SERVICE BULLETIN

FA14-001b

NOISE WHEN TURNING THE STEERING WHEEL

Direction of spacer installation

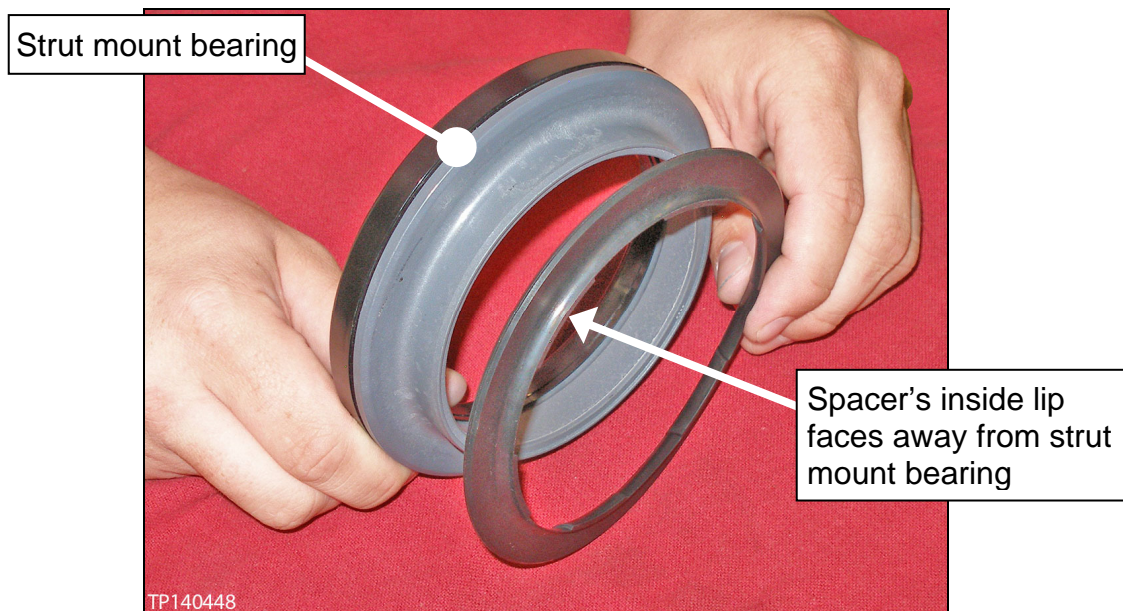
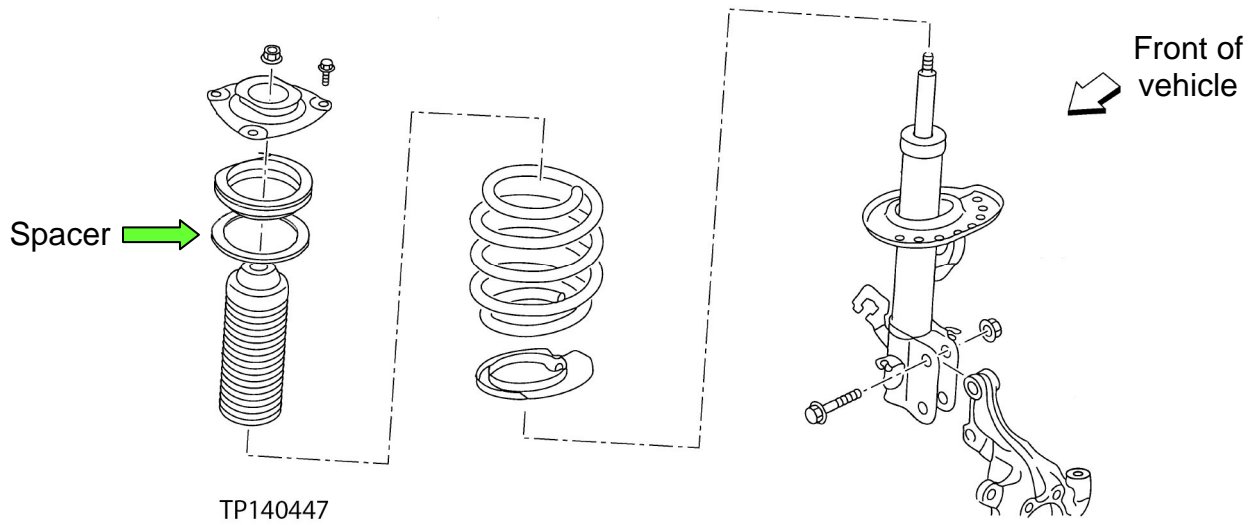
Install a spacer in both the left front and right front strut assemblies where shown in this bulletin.
